PROJECT:	Proposed Residential Development at Low Lane, Holbeach
HOUSE TYPE:	BLOCK PLAN P36-37
DRAWING:	Floor Plans & Elevations

SCALE:	1:50@A1	DRAWN:	JF
DATE:	06.12.2017	REVISION:	A
DRAWING No:	P36- 37-100

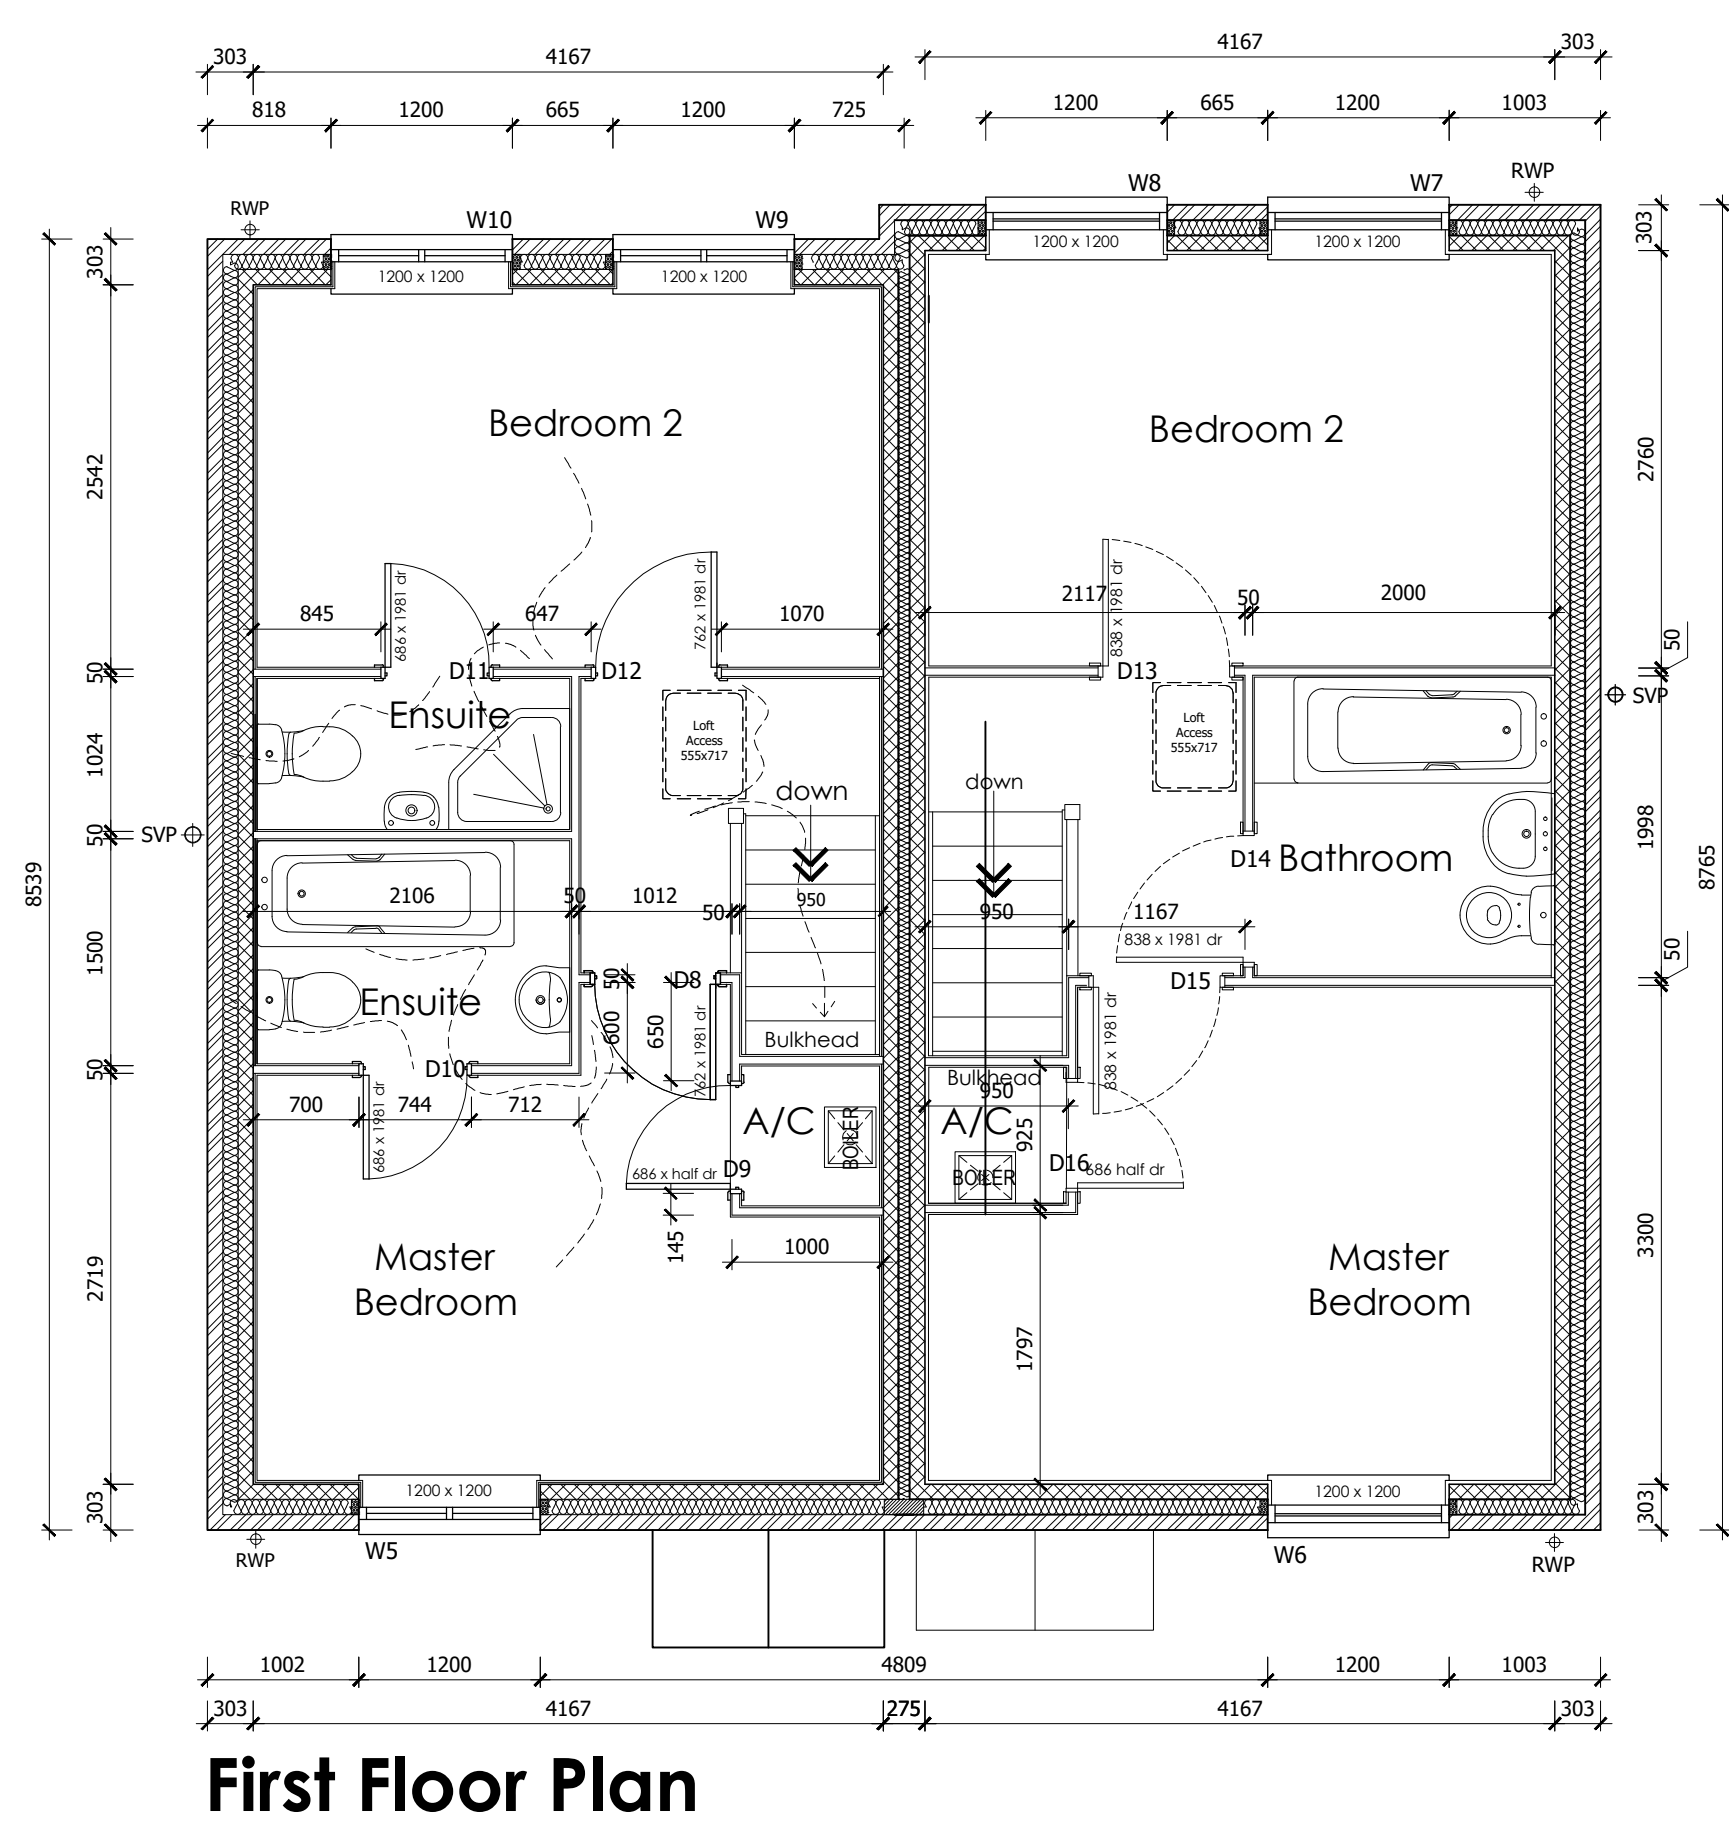
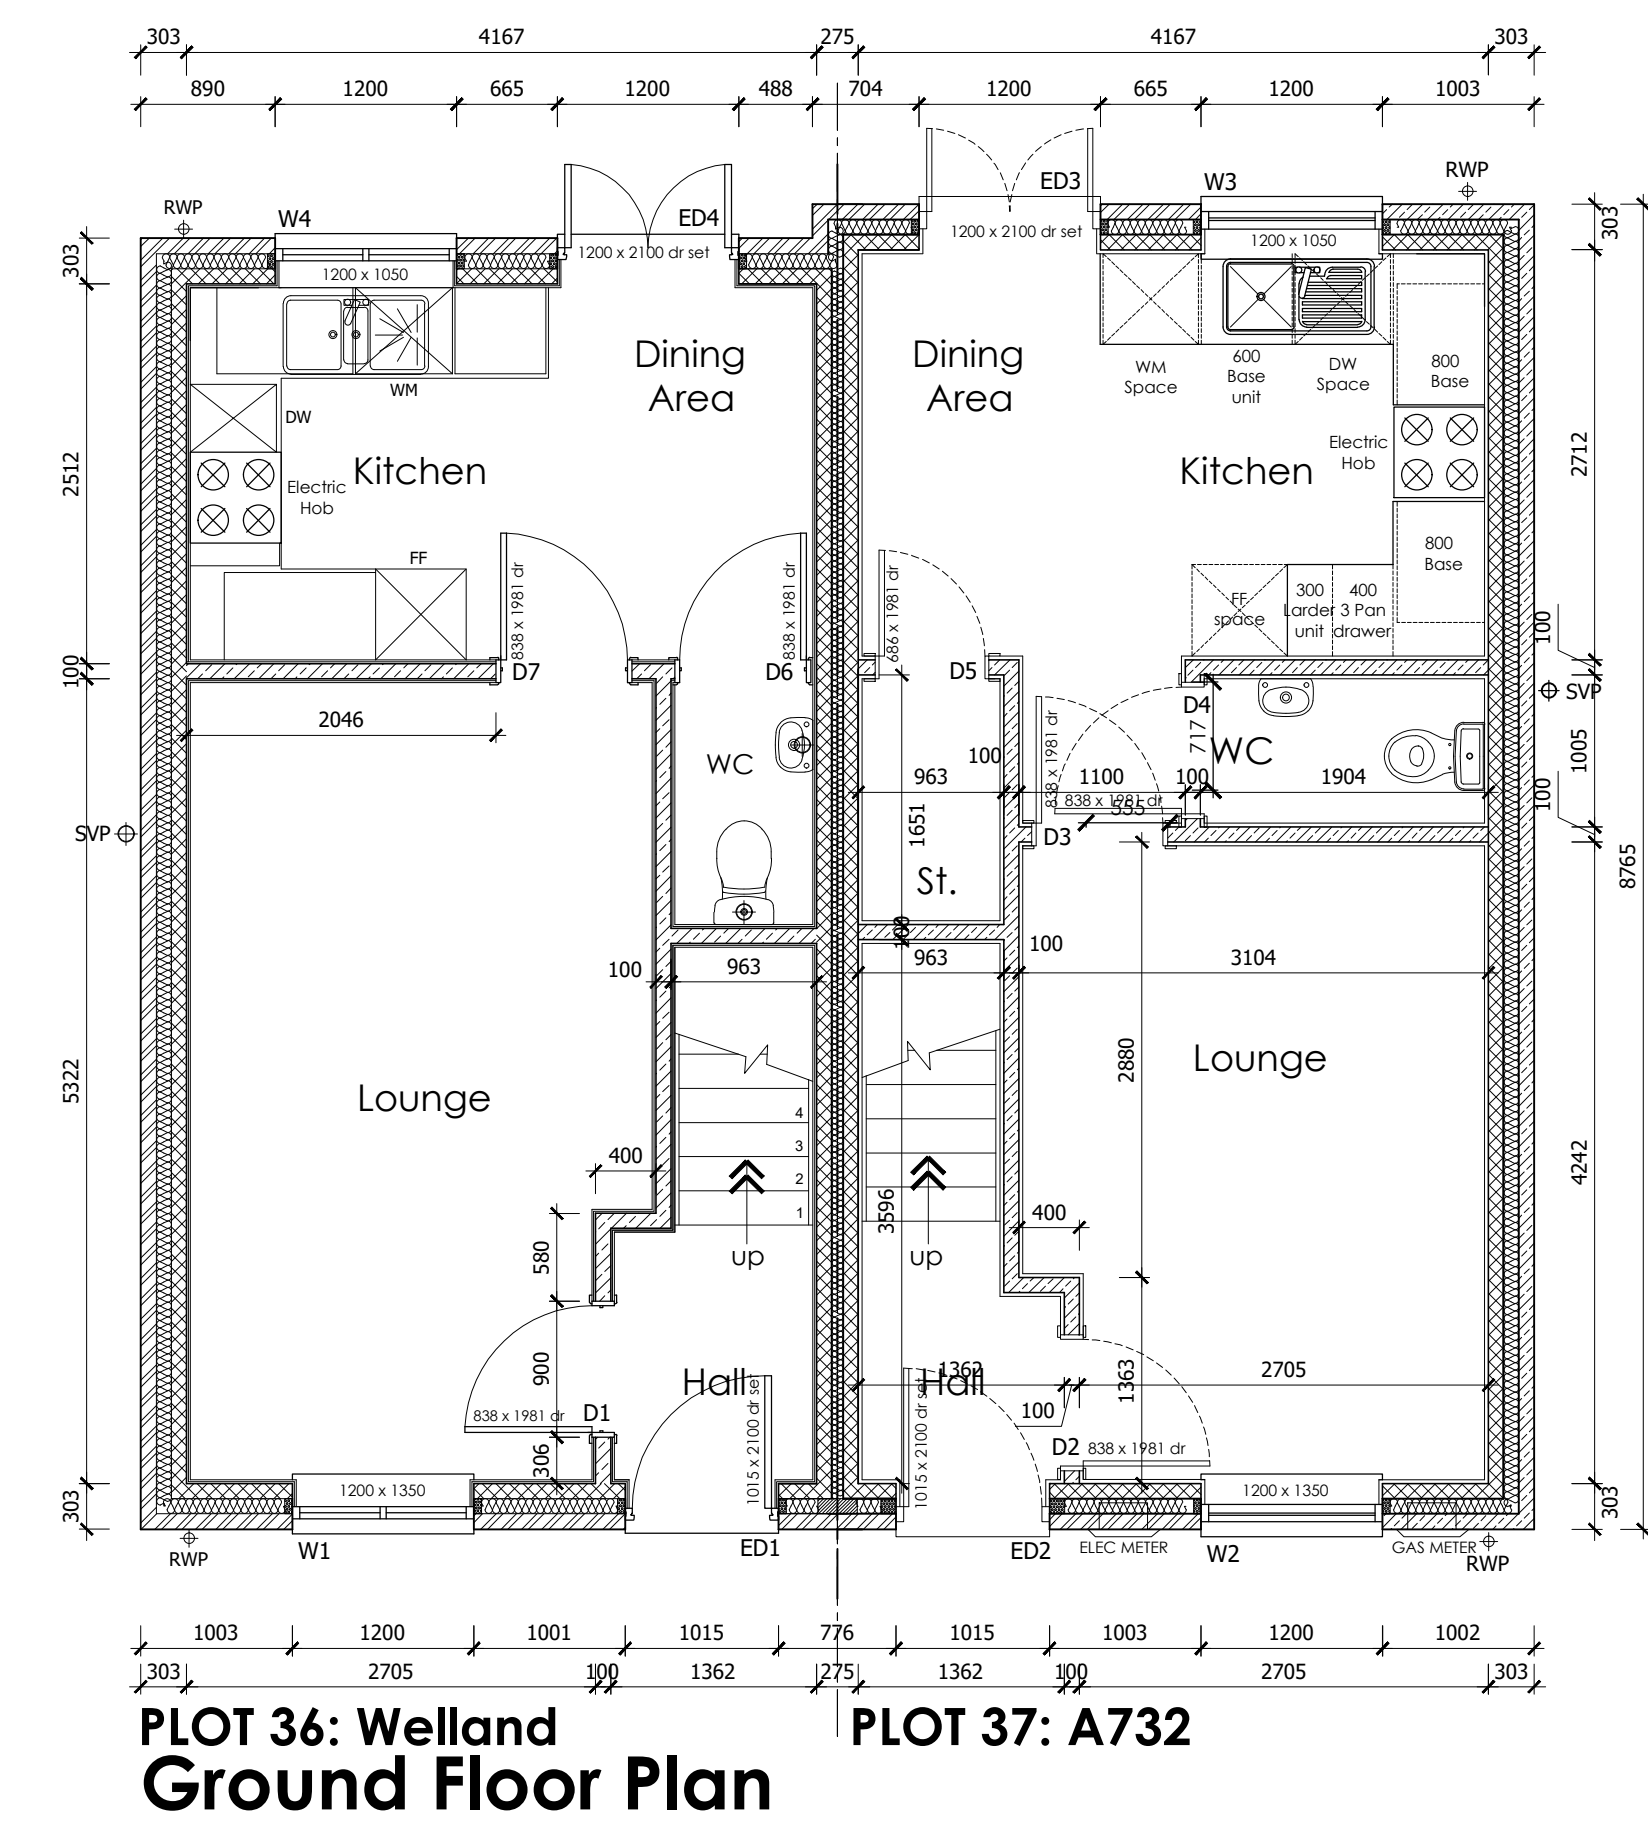
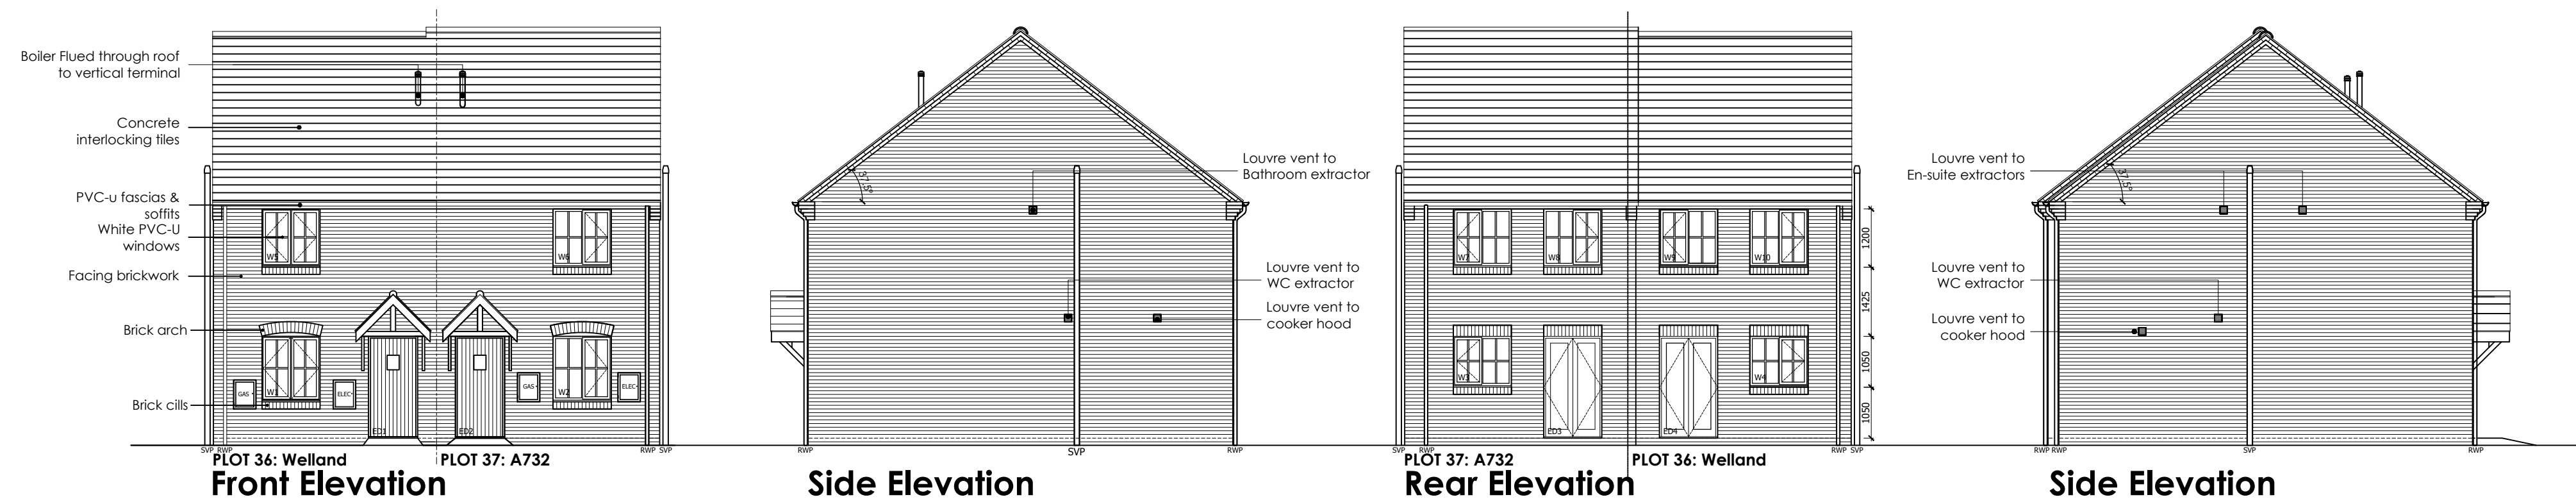
A.	16.01.18	Roof pitch on plot 36 (Welland) has been revised to 37.5°
Rev.	Date	Description
